Docket Item # 9 BAR CASE# 2009-0055

BAR Meeting May 6, 2009

ISSUE: Addition/Alterations

LOCATION: 911 South Saint Asaph Street

Figure 13: Floor Plan of the enclosed porch addition

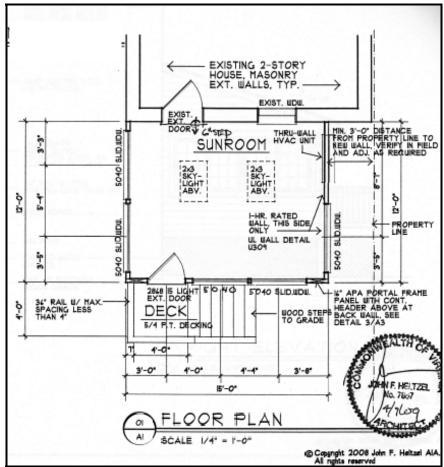
S1. Staff recommends that the lattice be constructed in a horizontal and vertical configuration, rather than diagonally as is the more typical historic lattice configuration in the district.

- C1. All exterior walls within 5 feet from an interior property line shall have a fire resistance rating of 1 hour, from both sides of the wall. As alternative, a 2 hour fire wall may be provided. This condition is also applicable to skylights within setback distance. Openings in exterior walls between 3 and 5 feet shall not exceed 25% of the area of the entire wall surface (This shall include bay windows). Openings shall not be permitted in exterior walls within 3 feet of an interior lot line.

Figure 14: Drawing of the enclosed porch viewing from the west

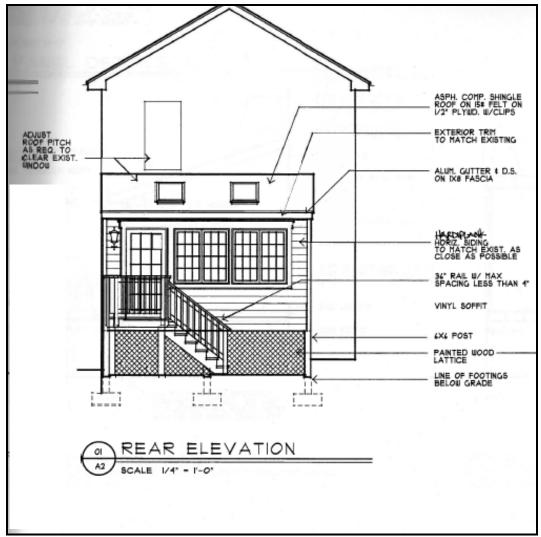
- 1. That all of the wood surfaces on the proposed wood entry staircase be painted or stained; and,
- 2. That the new windows will be simulated, divided light, wood clad slider windows, which contain 7/8" muntins that are permanently bonded to the interior and exterior of the insulating glass simulating a divided light appearance, with manufacturer specification cut sheets to be submitted to Staff for review and approval prior to the filing for a building permit.

The rear elevation of the porch will contain two sets of wood clad slider windows with divided-lights and a divided-light, wood clad door, accessed from a wood staircase. On the north elevation there will be two sets of wood clad slider windows with divided-lights detailing the elevation, while the south elevation will only be detailed with a set of wood clad slider windows with divided-lights, as this elevation abuts the neighbor's façade. The left elevation will also contain a thru-wall HVAC unit.

1. That all of the wood surfaces on the proposed wood entry staircase will be painted or stained; and

2. That the new windows will be simulated, divided light, wood clad slider windows, which contain 7/8" muntins that are permanently bonded to the interior and exterior of the insulating glass simulating a divided light appearance, with manufacturer specification cut sheets to be submitted to Staff for review and approval prior to the filing for a building permit.
